## QUALITY ASSURANCE -- NON-CONFORMANCE REPORT

**Report No:** NCR-000743

**Reference Description:** Unknown Material being tacked onto a Lift 13 Floorbeam. Performed work is not conforming to the requirements in AWS D1.5 Section 12.

**Job Name:** SAS Superstructure

**Component:** Lift 13E Floorbeam

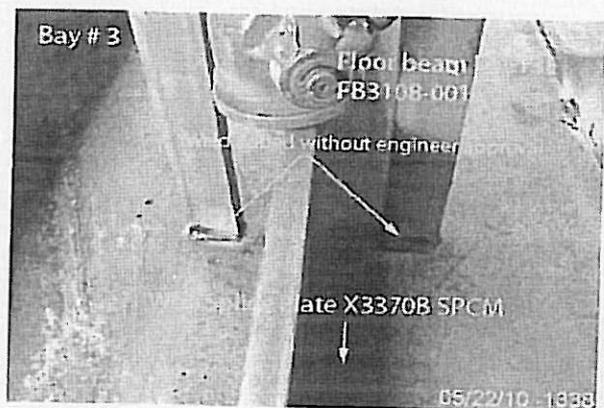
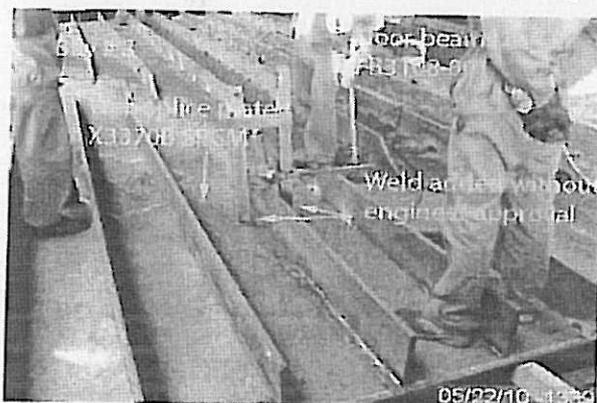
**Reference Description:** Unknown Material being tacked onto a Lift 13 Floorbeam. Performed work is not conforming to the requirements in AWS D1.5 Section 12.

During the Quality Assurance (QA) random visual inspection of Orthotropic Box Girder (OBG) Floor beam Lift 13E, this QA Inspector discovered the following issues:

- ZPMC has temporarily tack welded steel plate to a Seismic Performance Critical Member (SPCM).
- The approved shop drawings do not specify any welds in these areas.
- The size and length of the tack welds do not meet the requirements of AWS D1.5 2002, table 12.2.
- The member is a Floor beam identified as: FB3108-001.
- The location of the temporary tack welds are Floor beam web splice plate X3370B.
- The Floor beam web splice plate is designated on the approved shop drawings as SPCM.
- The material composition of the added steel plate being welded to the Floor beam is not known.
- OBG Floor beam FB3108-001 is located in the Bay 3.

Remove welds, grind base metal under tacks, perform base metal repairs and NDT required to verify weld quality.

Contractor submitted post repair NDT documentation verifying base metal has been repaired and repair welds meet Contract weld quality requirements. ZPMC has also issued a temporary attachment procedure to Production to eliminate recurrence of this problem.
